CONSOLIDATED EDISON COMPANY OF NEW YORK, INC.

Indian Point Station, Unit No. 2

Applicant's Responses to Round Two Questions
Submitted by The Citizens' Committee for the
Protection of the Environment (Set H)
on March 9, 1971

March 31, 1971

Fig. 29-2 Low Altitude Flights Within 10 Miles of Indian Point. (From N.Y. Center VOR Peak. Day Chart Sept. 5, 1969)

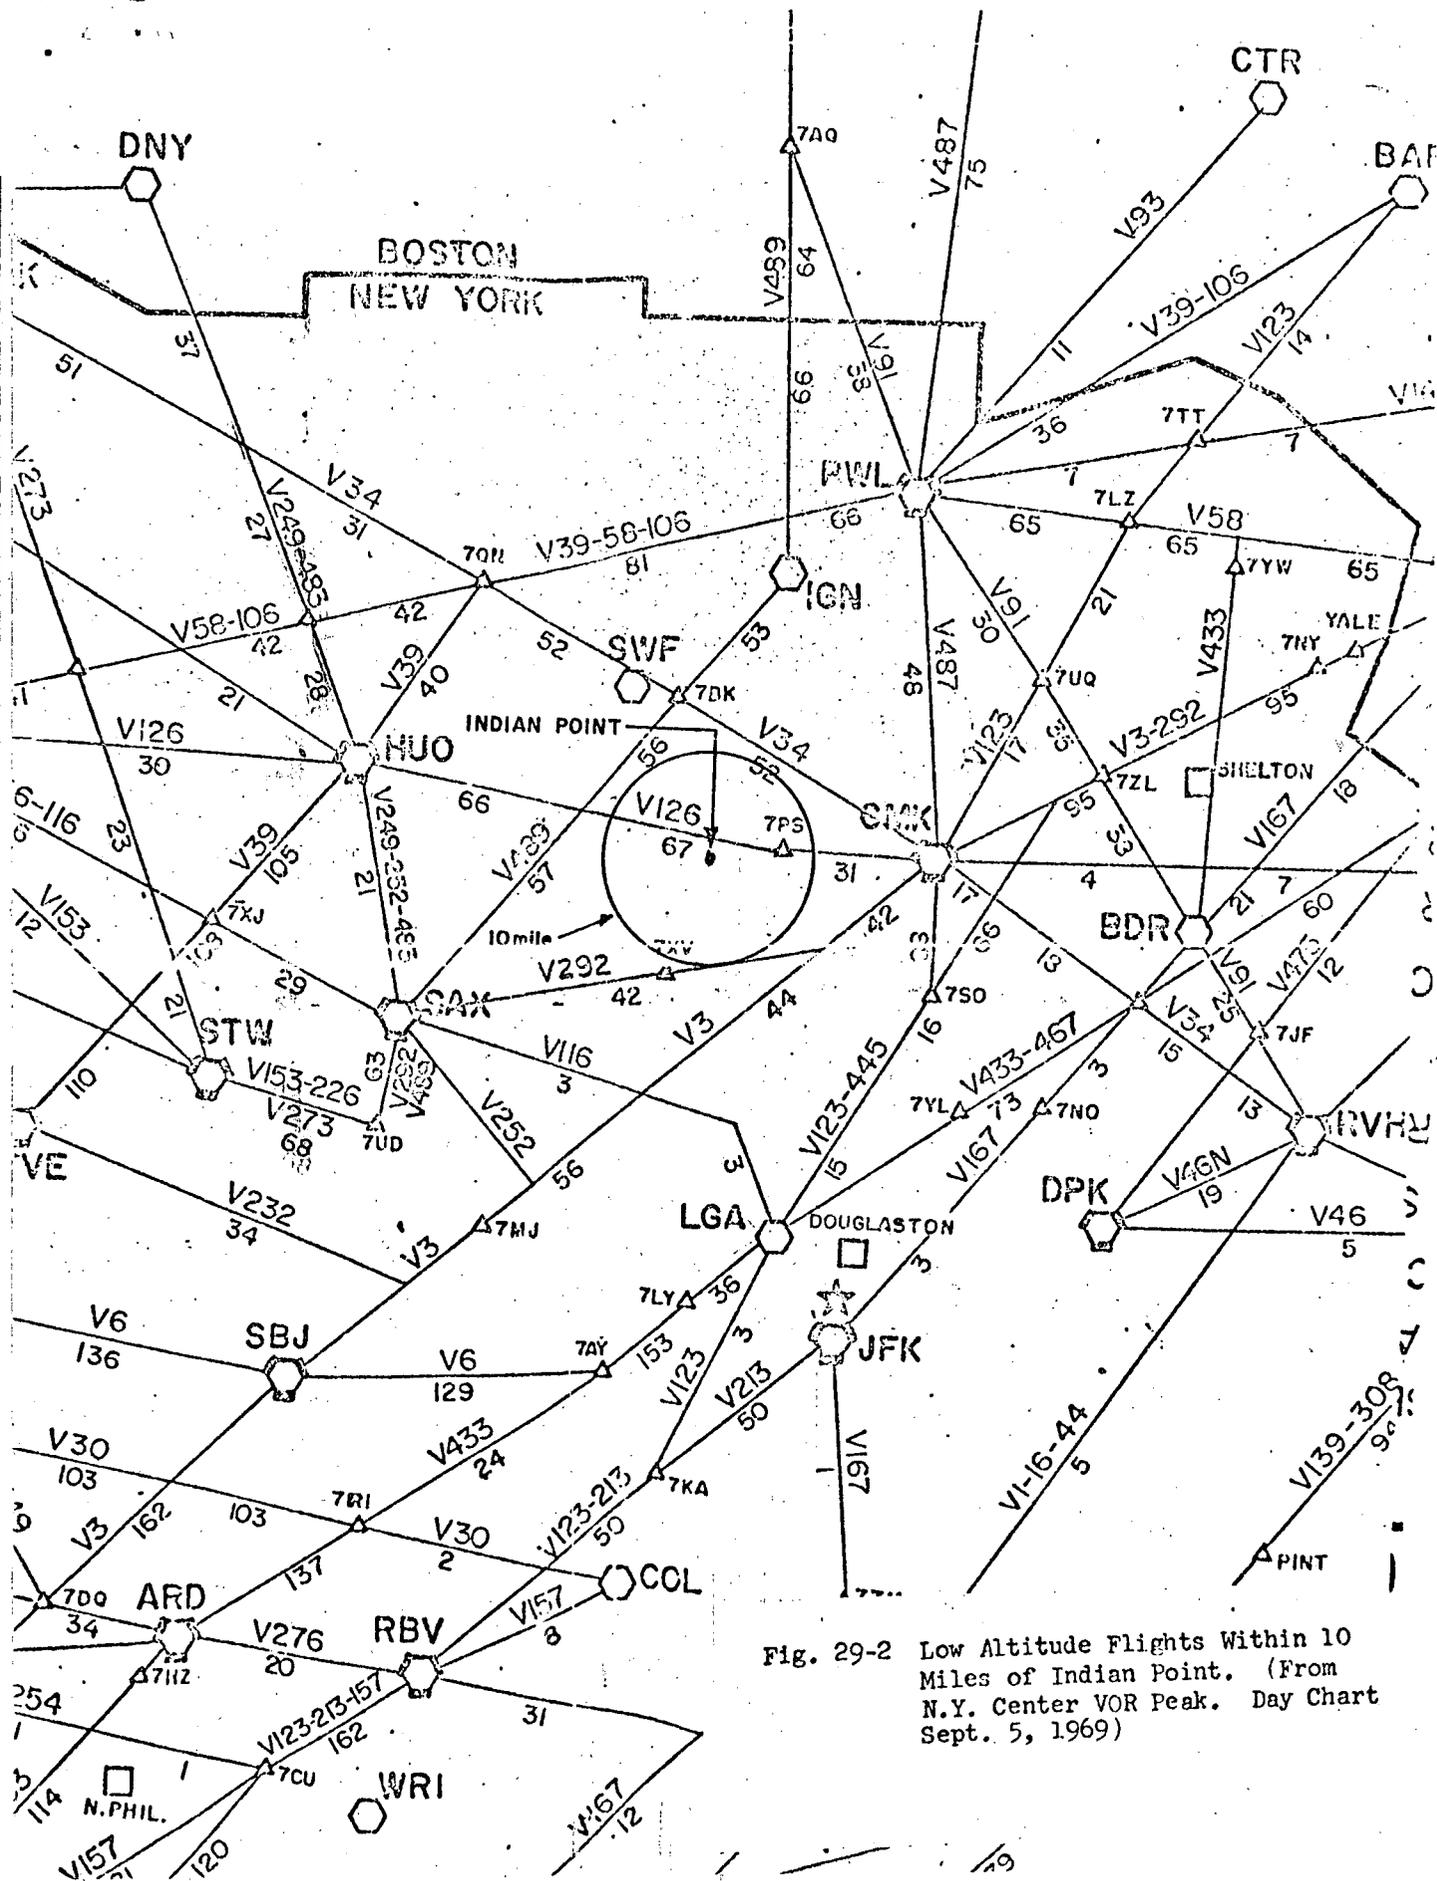
Question: On Page 3 of Answer E-17 and D-1 you indicate that because Indian Point No. 2 is not in the "High density accident area" associated with glidepaths for take-offs and landings in the immediate vicinity of the airfields no analysis needs to be done of the possible crash of a 300,000 lb. aircraft into the reactor. Justify this decision and discuss or reveal, inter alia, the following factors:

- a. Show flight routes and holding patterns for all three major New York airports as well as the Westchester County airport for all routes and holding patterns within a 10 mile horizontal distance from Indian Point. If you are unwilling to answer because you believe 10 miles is too large explain in detail your reasons and answer the question for the acceptable distance.
- b. Indicate with respect to these routes the average number of airplanes on the route each year and their average altitude.
- c. Indicate the number of mid-air collisions between airplanes one of which will land or has taken off from the airports involved, in the last ten years.
- d. Indicate what data was obtained from which FAA officials with respect to your inclusion that the crash of an airplane into the reactor is so incredible that no analysis of the effect of that accident is required.

Answer: a. The flight routes within 10 miles of the Indian Point Plant are shown on Figures 29-1*, 29-2*, and 29-3*. The Brewster holding pattern shown on Figure 29-4** serves Westchester Airport, which is used primarily by smaller aircraft (BAC-111 and FH-227 type aircraft). The New York Metroplex is shown in Figure 29-5.

- b. The number of aircraft which pass within 10 miles of the Indian Point Plant on the designated airway routes and on direct flight paths between intersections are tabulated below. The numbers tabulated are for September 5, 1969, which was the day during 1969 when the New York Center for air traffic control handled the most flights.
